Begbroke Innovation District

Supplementary Transport Information

OXFORD UNIVERSITY DEVELOPMENT

Document:	Supplementary Transport Information
Project:	Begbroke Innovation District
Client:	Oxford University Development
Job Number:	22034

Figure 4.1: Parameter Plan 4 Access and Movements Plan

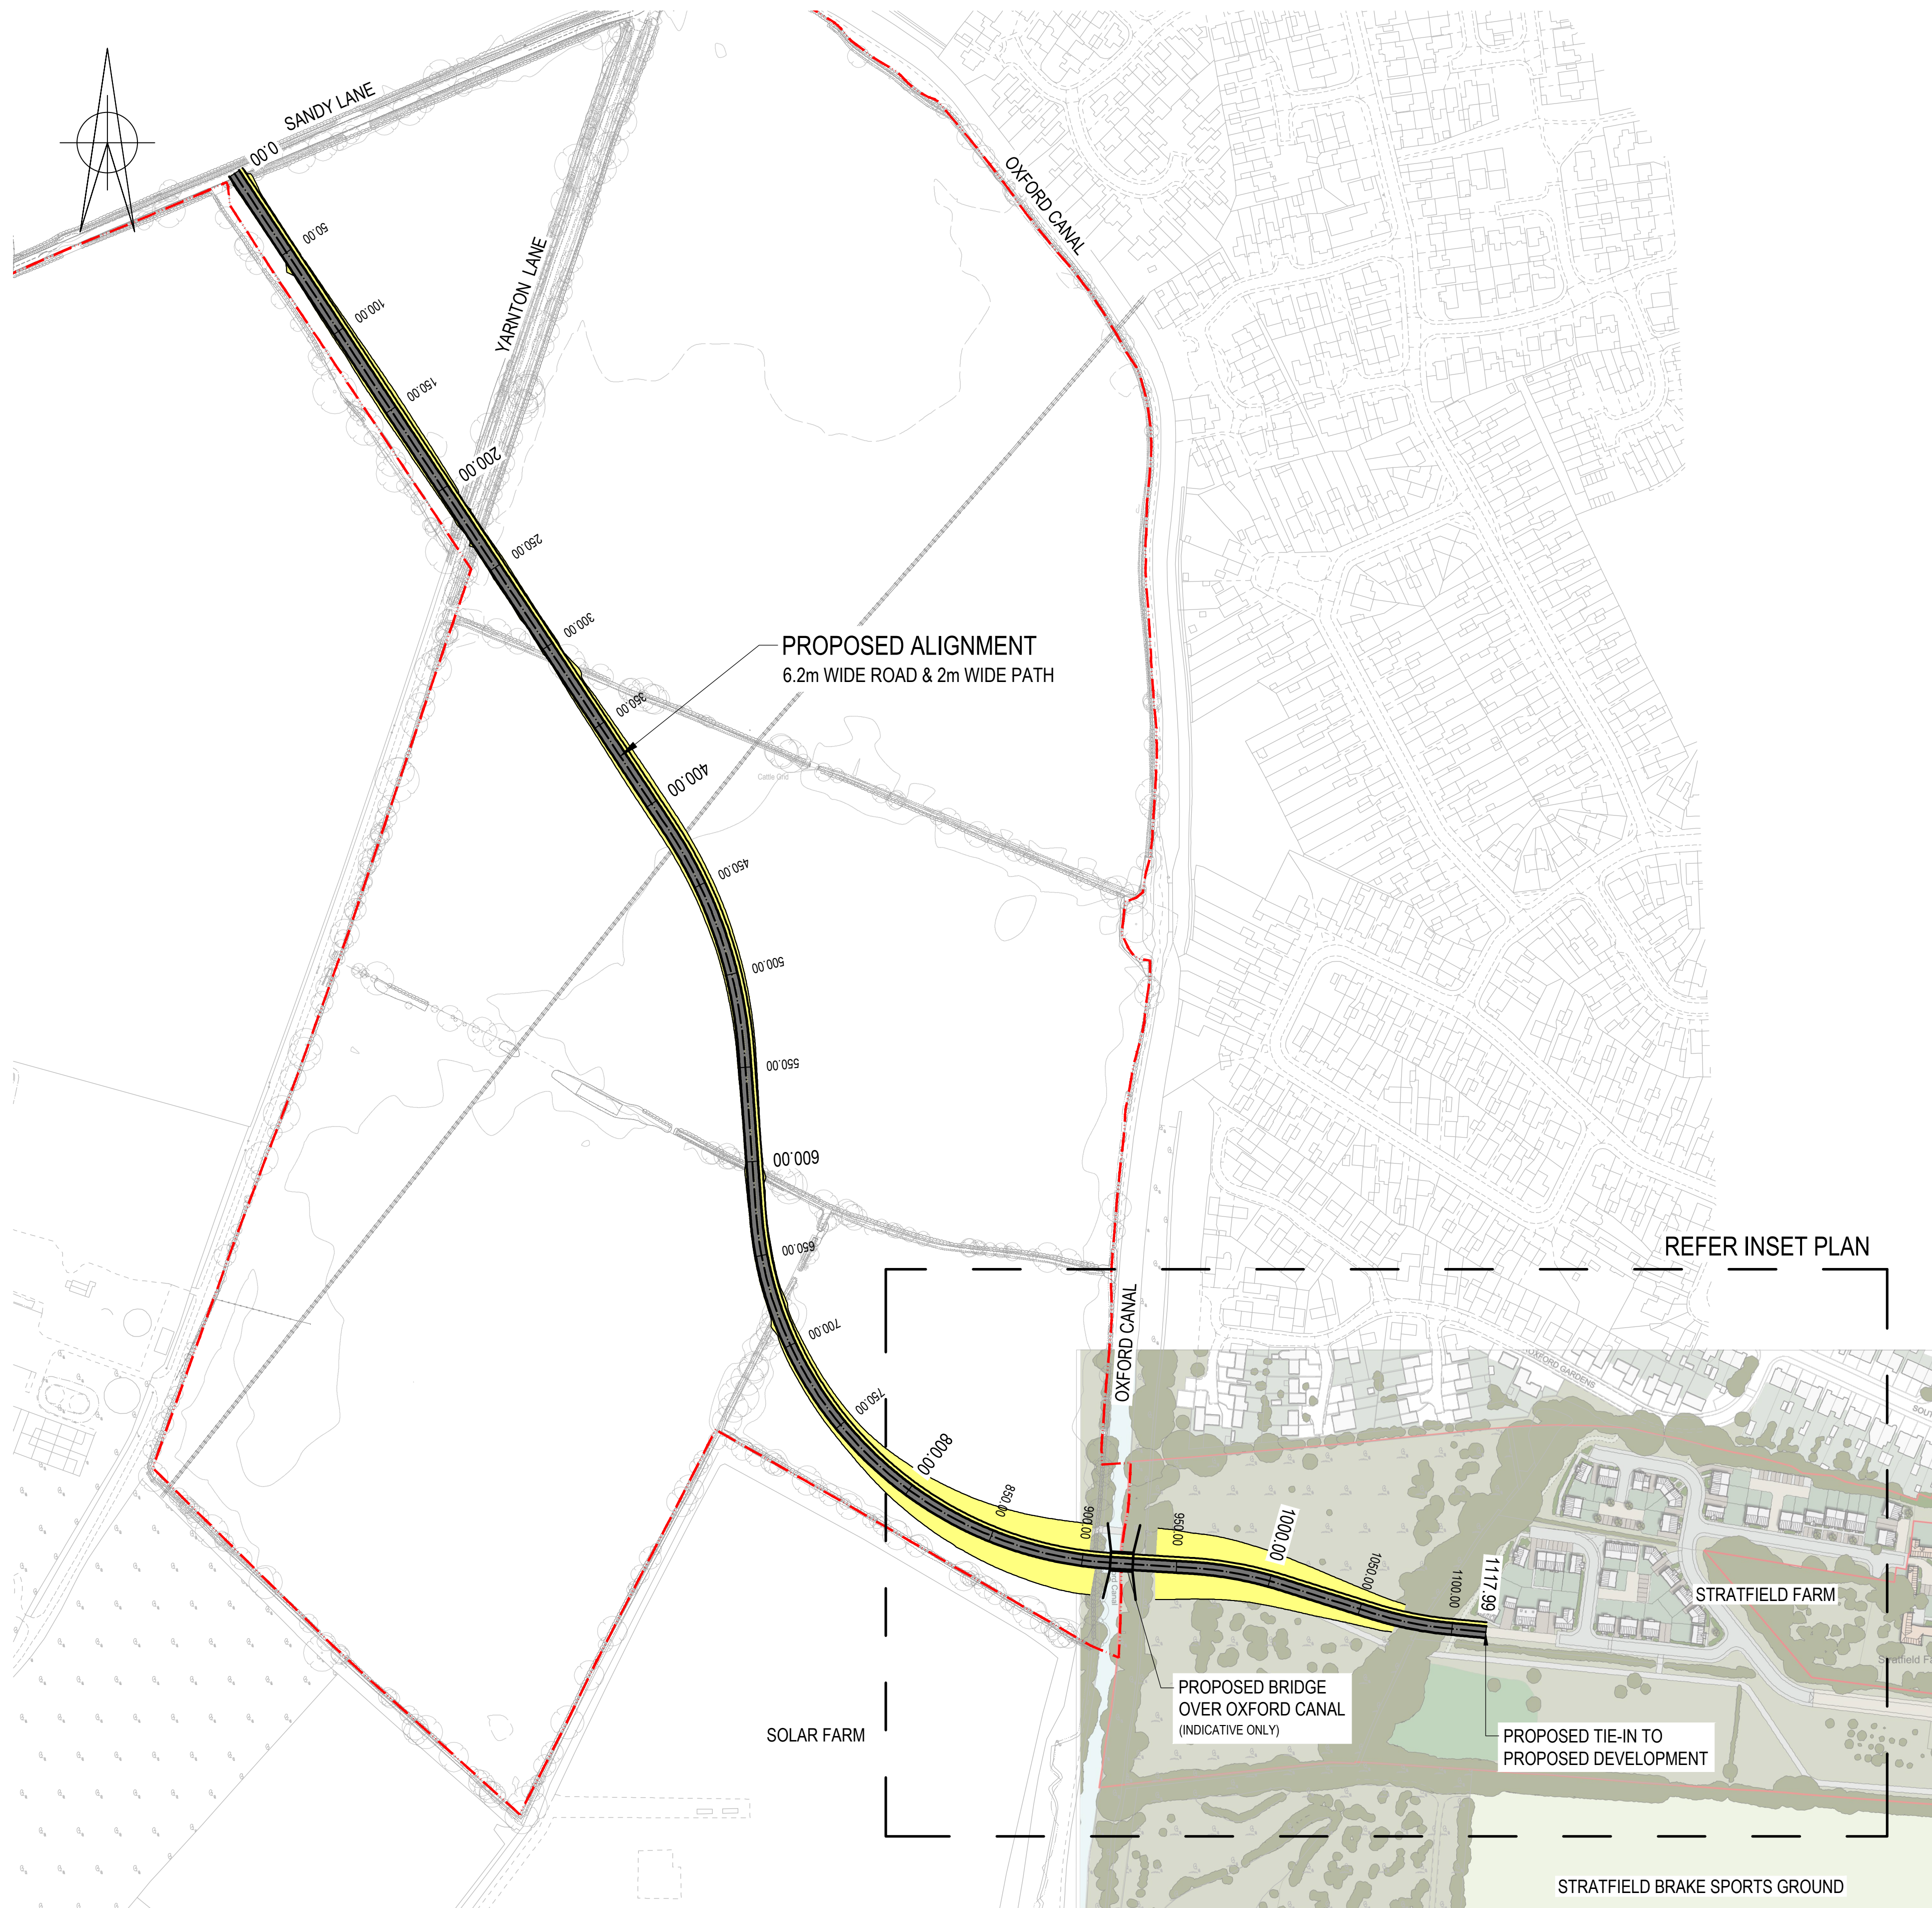
'Any illustrative linkages into and out of the site, including bridges, should be secured by strong and robust planning conditions / obligations. These should be applied to any future consent, ensuring the requirement for pedestrian and cycle routes to existing and future infrastructure be adopted by the highway authority up to the red line boundary'.

- 4.4.1 Parameter Plan 4 on Access and Movement sets out the access and movement parameters for the proposed development. It is a Control Document, and compliance with it will be a condition of any outline planning permission. The requirement to secure the links to and from the site via appropriate obligations or conditions is agreed. The adoption of highways and active travel infrastructure within the site to connect to the external active travel network will form part of Tier 3 reserved matters applications for individual parcels of land.

- 4.4.2 The proposed points of access are detailed in Parameter Plan 4 Access and Movement Plan. This is presented in **Figure 4.1**.

4.4.3 The points of access are identified to connect with existing routes, many of which will be improved through developer S106 contributions, which will include contributions from OUD for the Begbroke Innovation District. Active Travel links will be incorporated to each. The detail of these connection points will be determined through the area-specific masterplans and the detail that will come forward through the detailed design of wider Local Plan-led linkages.

Figure 1: Bus Lane Set-Up in VISSIM

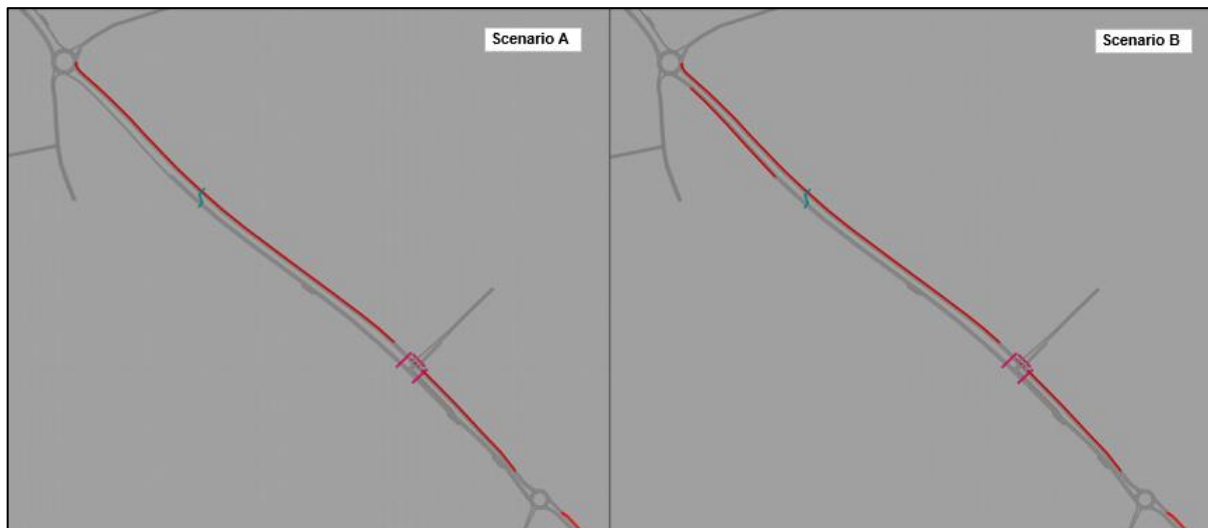
- 2.15.2 Following the submission of the planning application, OCC raised concerns with the cumulative impact of the PR sites on bus journey times on the A44 and requested two sensitivity tests were undertaken using the VISSIM model. This was undertaken and submitted to OCC. A technical note summarising this sensitivity test is included as **Appendix C** of this submission. OCC's consultation response stated that the bus lane sensitivity test demonstrates the effectiveness of the bus lanes in mitigating the impact on bus journey times. No further modelling has been requested by OCC and it is considered that the assessment of the effects of the proposed development and cumulative effects of the PR sites is now accepted by OCC.

4. The two bus lane tests are:
 - a. A southbound bus lane added between the A44/Sandy Lane/Rutten Lane Roundabout and Cassington Road Roundabout.
 - b. Above, plus a northbound bus lane added on the approach to the A44/Sandy Lane/Rutten Lane Roundabout.
5. The model coding for Scenario A (SB only bus lane), and Scenario B (NB + SB bus lanes), is shown below in Figure 1. The bus lane sections are highlighted in red.

7. Results show that the addition of the southbound bus lane results in journey time improvements on the A44/A144 SB and NB routes. The main journey time saving on the A44 SB is between Sandy Lane and Cassington Road roundabouts, where the new bus lane is located. The individual journey time sections along this route demonstrate that some delay is shifted north of the Sandy Lane roundabout as private vehicles lose the second lane between Sandy Lane and Cassington. Overall however, the southbound buses show a considerable net reduction in journey times compared to the original DS scenarios.

9. When the northbound bus lane section is added in Scenario B, the A44 northbound generally shows additional journey time reductions as the buses are able to bypass the queues on the approach to Sandy Lane roundabout. It is demonstrated in the individual journey time sections in Appendix A that instances where the northbound route has higher journey times in ScB compared with ScA are because of small journey time variations elsewhere; A44 northbound to Sandy Lane improves in all B scenarios compared to A.
